To:	All plan holders	From:	Tracy Bruun, Division
Pages:	59 pages including this cover page.	Phone:	515-725-4119
Re:	Gre853235C Nutrient Reduction Wetland (Bid 23-05)	Date:	September 11, 2023

Subject: **Addendum No. 1** to Bid Documents
Gre853235C Nutrient Reduction Wetland Project – Bid No. 23-05
Greene County, Iowa

GREENE COUNTY WETLAND PROJECT
GRE853235C - BID NO. 23-05
PREBID MEETING
August 28, 2023 - 1:00 PM

CUT-FILL REFERENCE SHEET

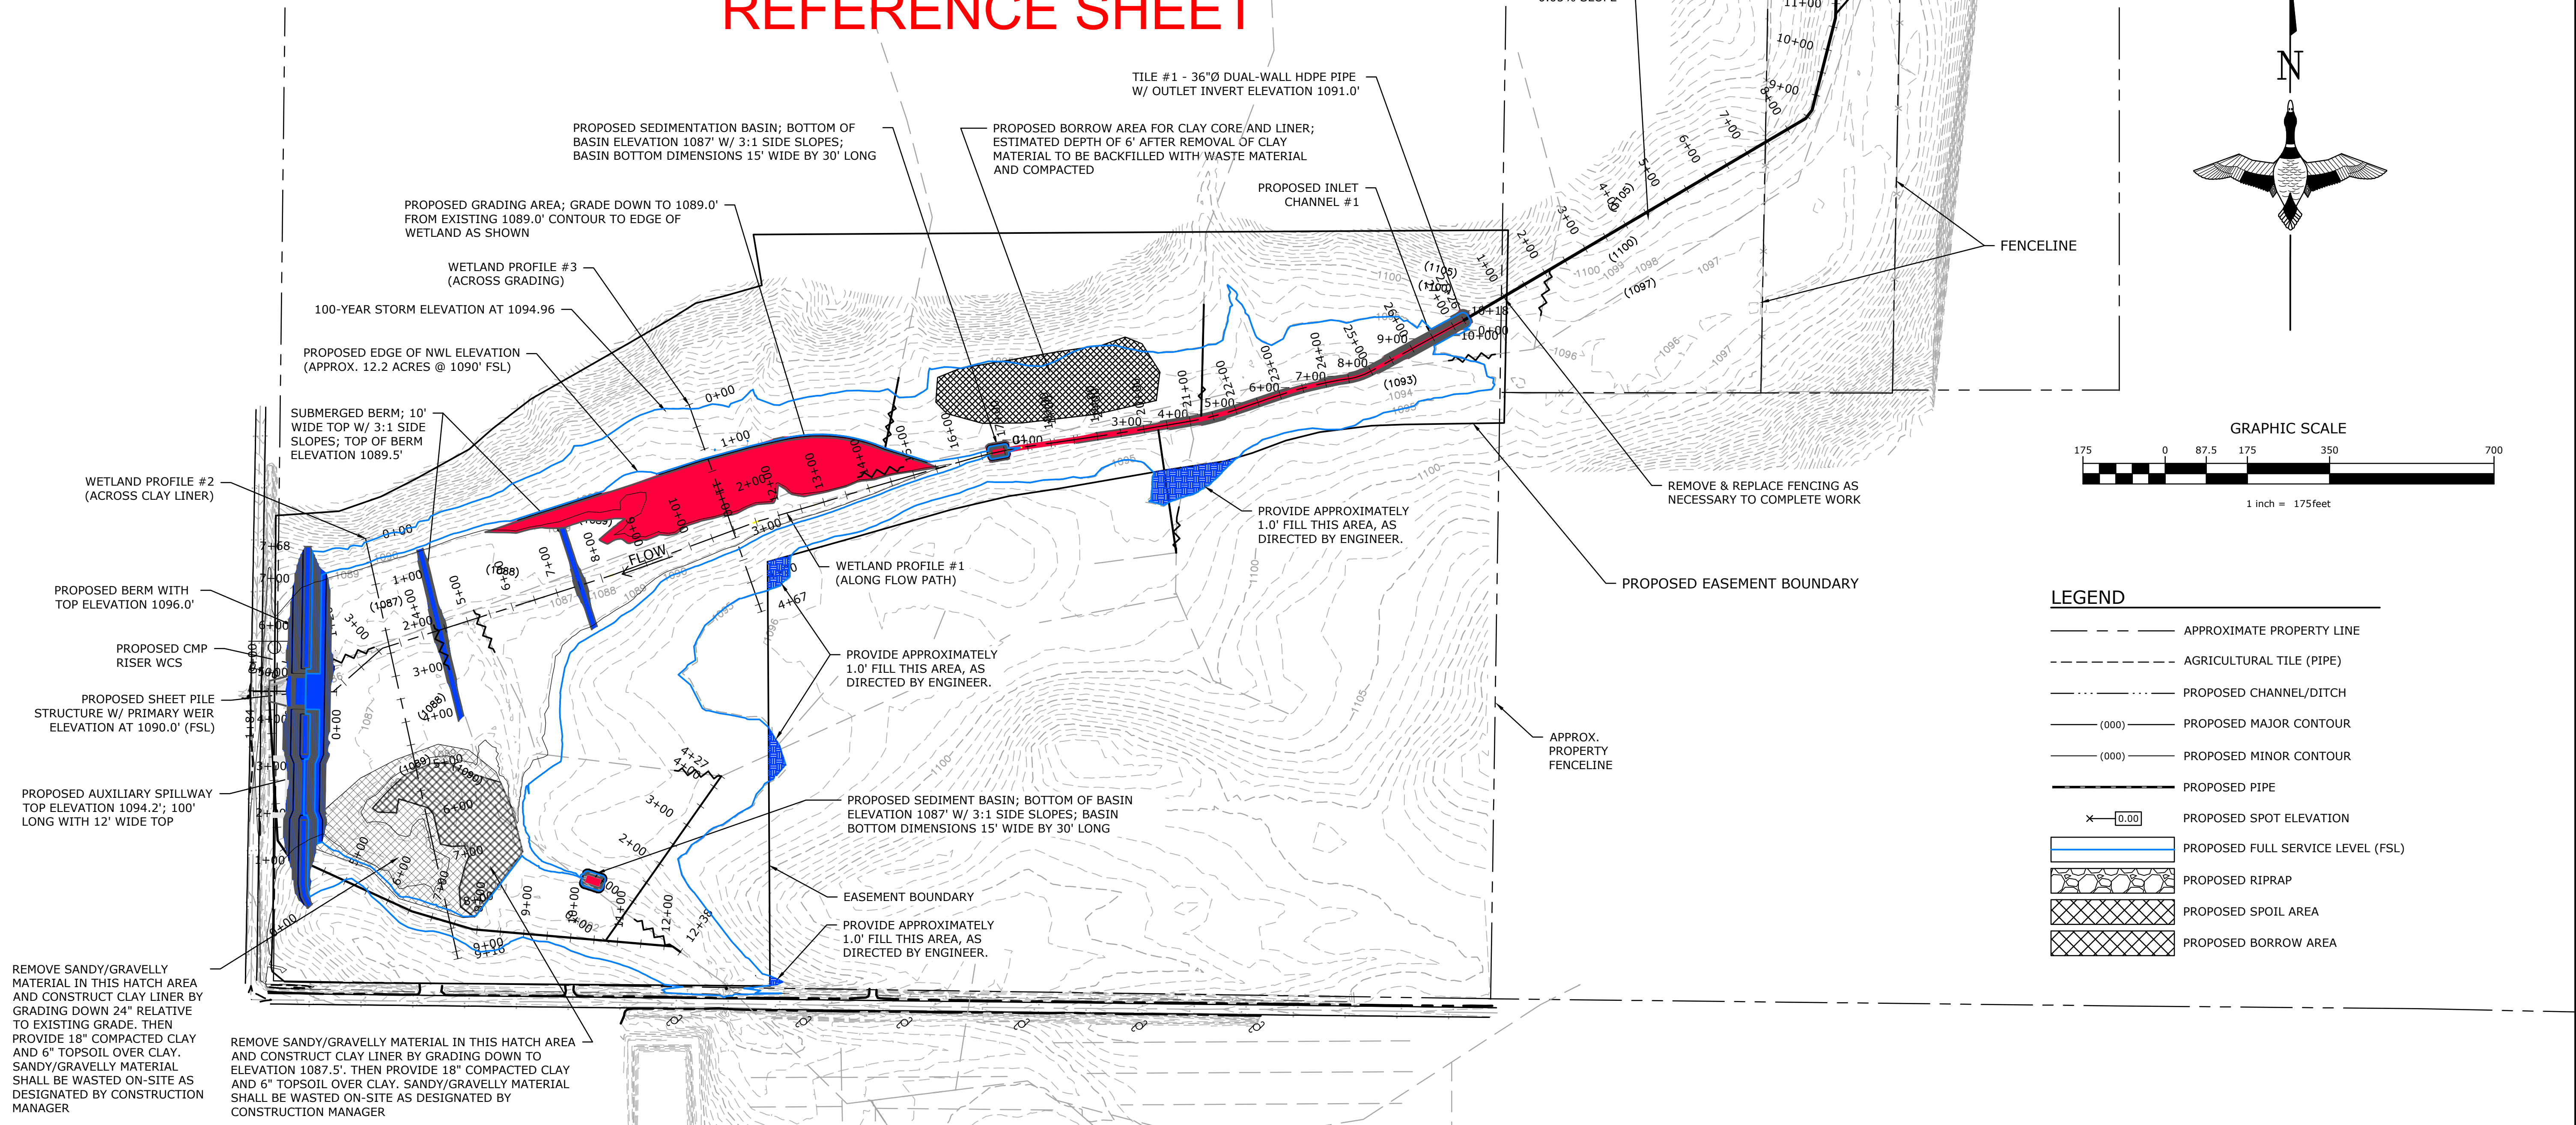
Q: Can a color cut-fill map be provided?

A: Yes. It has been added with this submittal.
